**Competitive Design Alternatives Report
(D2)**

903 – 921 Bourke Street, Waterloo (Process 2)

On behalf of:
Dahua Group Waterloo Project Pty Ltd
April 2020

Figure 21 Previous and revised approach to through site links from Bourke Street
Source: DKO, *Breathe and Oculus*

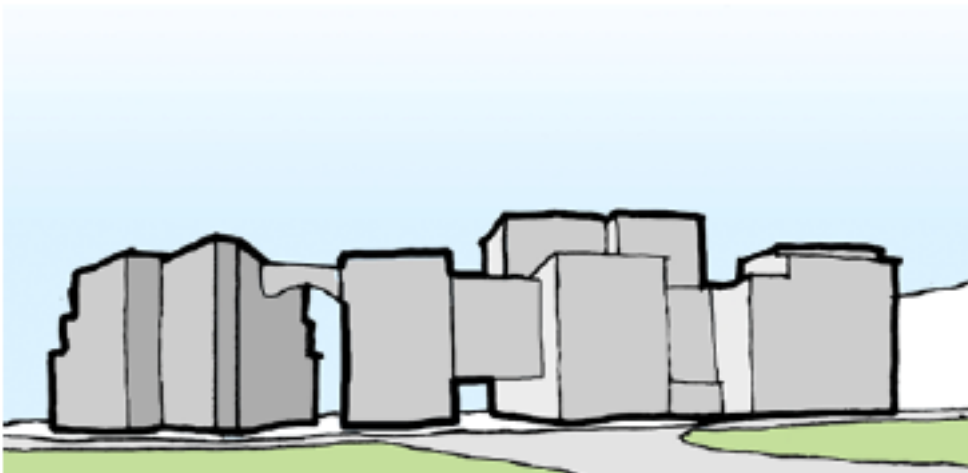
- The revised scheme amended the additional through site links by incorporating additional massing above the links. This was intended to overcome the potential impacts on acoustic and visual privacy. An acoustic assessment accompanied the revised scheme which outlined mitigation measures.

Figure 24 Relocation of balconies effected by internal acoustic impacts

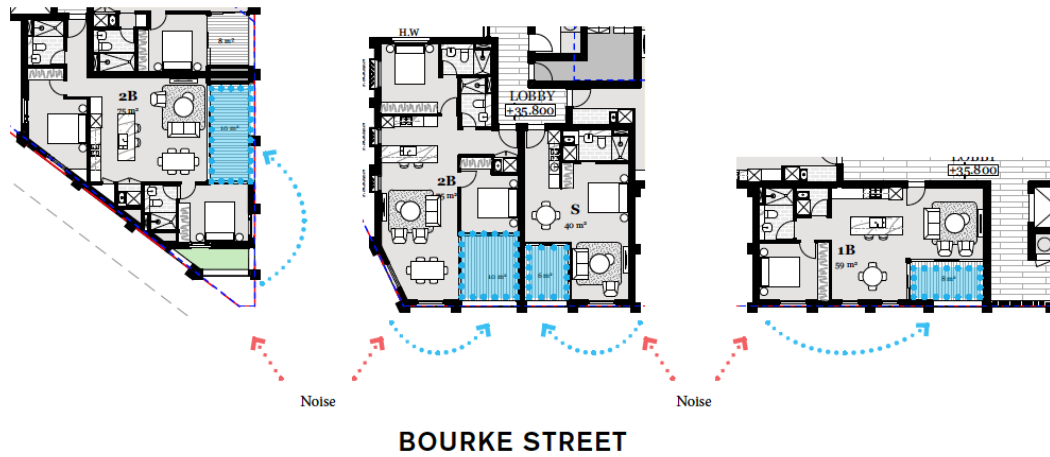
- Balconies and room layouts were reconfigured on to account for acoustic impacts.
- Further examination of building separation and the orientation of habitable/non-habitable rooms was provided.

Figure 29 Option 4 of 5 (the Jury's preferred option) for the ground floor plan

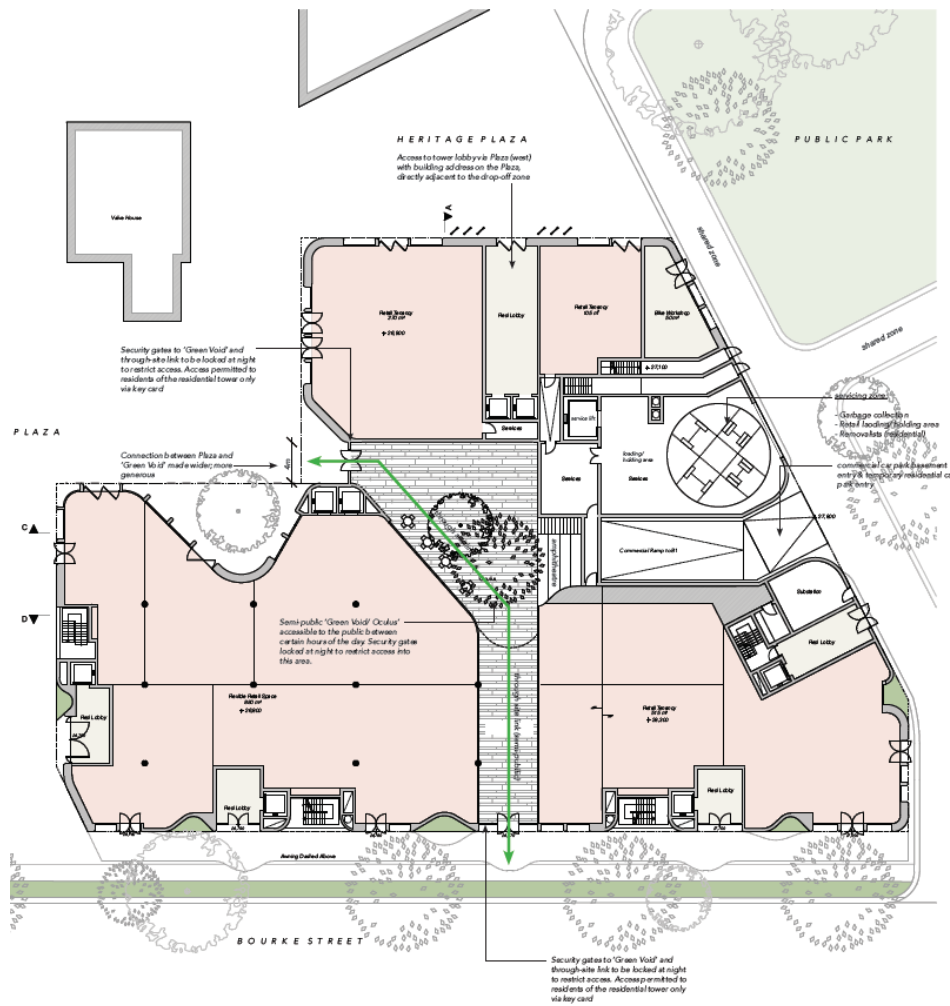
- Due to unknown project staging, car park access to the basement needs to be incorporated on the ground-level plan (no need to amend the basement level).

- It is hard to achieve acoustic privacy with balconies that face each other. This will require further resolution as part of the DA preparation.
- MHNDU's revised scheme better addresses the ground-plane – however, the access point from the plaza could be widened to further improve it. The strong flexibility of the scheme means that these matters can be reconfigured, which demonstrates the scheme's strengths.
